OPTIONAL SERVICE BULLETIN NO. OSB D4-111 REV. 0

Installation of a new production TAE 125-02-99 engine (S/N 02-02-06000 and subsequent).

WORK INSTRUCTION WI-OSB D4-111 REV. 0

Figure 1. Changes to the oil system on the new production engine.

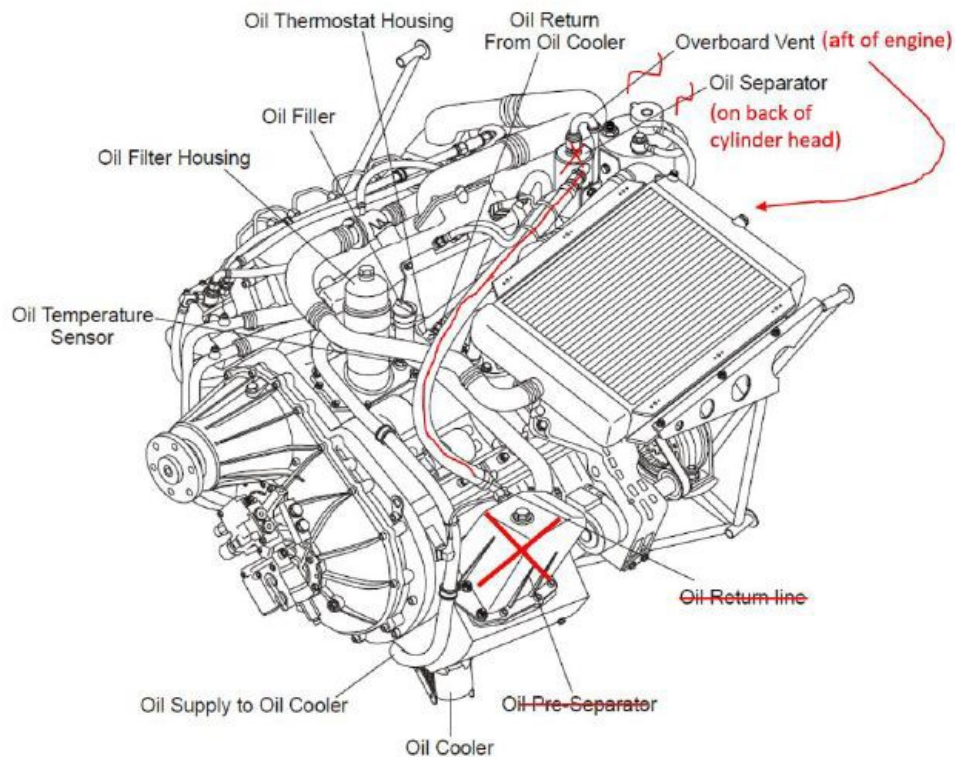
Continental Aerospace Technologies GmbH has introduced the following changes into the TAE 125-02-99 engine: A new cylinder head cover, updated features to secure the fuel return line, the replacement of the cyclone oil separator with a centrifugal separator, and a new vacuum pump. These changes are contained in the engine assembly, and should not affect the physical installation of the engine onto the airplane. This service bulletin describes the physical differences between the new and old production engines, and allows for the retrofit of the new production TAE 125-02-99 engine on G1000-equipped DA 40 D aircraft equipped with old production TAE 125-02-99 engines.

NOTE: The differences between the older and newer production engines are largely contained in the engine assembly. Install the new production engine in accordance with AMM Section 71-01-00. Refer to the figures for an overview of the physical differences on the new engine.
